Docket Item #9
DEVELOPMENT SITE PLAN #2004-0016
FANNON PROPERTY

Planning Commission Meeting
January 3, 2006

ISSUE: Consideration of a request for a development site plan, for construction of 58 multi-family residential units.

D. Open Space- Streetscape Improvements:

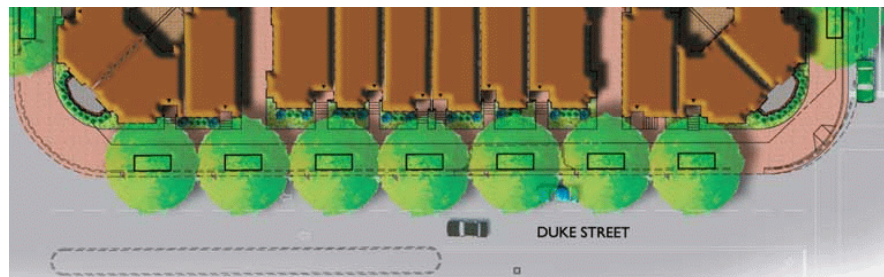
As part of the proposal, staff has worked with the applicant to provide all of the open space at grade and to be useable and consolidated open space. In addition, staff has worked with the applicant to make sure that a significant portion of the open space is visually accessible from Payne Street, as well as Duke Street and to provide a sense of “openness” for the development. Currently there is no useable open space on the existing site. The applicant has proposed a total of 45% ground level open space interspersed within the internal courtyard and at the perimeters of the site adjacent to public streets.

Staff has worked with the applicant to provide an 14ft brick Existing Payne Street pedestrian sidewalk and, in addition, many of the units will be setback up to 10 ft. to create small front yards, green space and “openness” on the street. The setbacks will provide an opportunity for landscaping adjacent to the Duke Street frontage, typical of other units on Duke Street or other units within the Historic District of those styles of architecture.

Staff has worked with the applicant to provide an approximately 140 ft. x 40 ft. open space courtyard on Payne Street on the southern portion of the site. The open space will provide a significant amount of relief from the scale of the building, reinforce the character of the street as residential street and provides a buffer to the adjoining commercial office building east of the site.

Staff is also recommending a 12ft. wide brick sidewalk, that will connect to the Old Town Village sidewalk to Duke Street and provide a continual landscaped pedestrian walkway on Payne Street which is, today, characterized by curb cuts, parking lots, and a lack of connectivity.

Internal Courtyard:

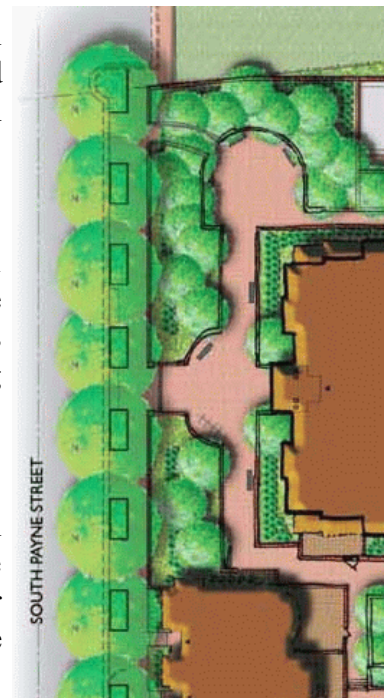
The applicant is proposing an approximately 140 ft. x 40ft internal courtyard. Rear yard areas are proposed for all of the townhouse style units framing the courtyard on the north side. Pedestrian walks connect the courtyard to West, Payne and Duke Streets, providing visual and physical links to the street from within, and, conversely, views into the landscaped courtyard from the public streets.

The central courtyard has been designed to provide pedestrian gathering spaces for residents. Trees and landscaping will provide relief from the paved areas in substantial planter areas. A main stair and elevator accessing the garage is located in a central portion of the courtyard.

Proposed site showing 18 townhouse lots

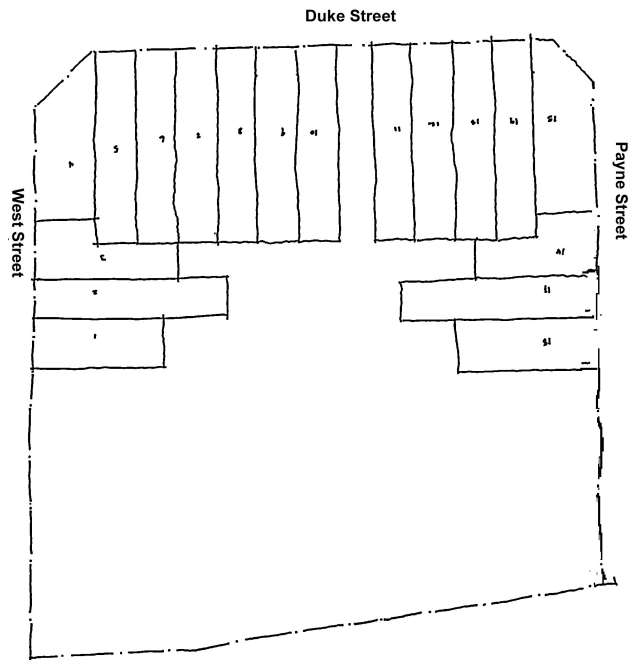
In order to achieve smaller townhouse scale buildings on Duke Street, the applicant is proposing “townhouse-style” condominiums on Duke Street. The applicant initially proposed this type of unit as a way to provide additional open space and to provide more creative corner units, which could not typically be provided with fee simple lots. The Zoning Ordinance defines townhouses as dwelling units separated vertically through the building by a party wall that runs from the basement to the roof. While the units will function as townhouses with a vertical party walls, the party wall will not extend to the underground garage.

The Commission and Council have provided clear direction to staff that the use of “townhouse-style” condominiums should not be a way to provide additional units but would be considered as a way to provide a more creative layout. In this case, the use of “townhouse-style” condominiums does not allow additional density, (FAR or units), on the site. In fact the requirements, FAR, open space and height are the same in the OC zone, unlike other zones where greater density is permitted for multi-family buildings. In addition, staff prepared a “conventional layout” as depicted in the graphic, which indicates that 18 fee simple townhouses can be provided with a multi-family building on the southern portion of the site. The applicant is providing the same number of “townhouse-style” condominiums (18), and, a multi-family building on the southern portion of the site with both schemes permitting an FAR of 1.25.
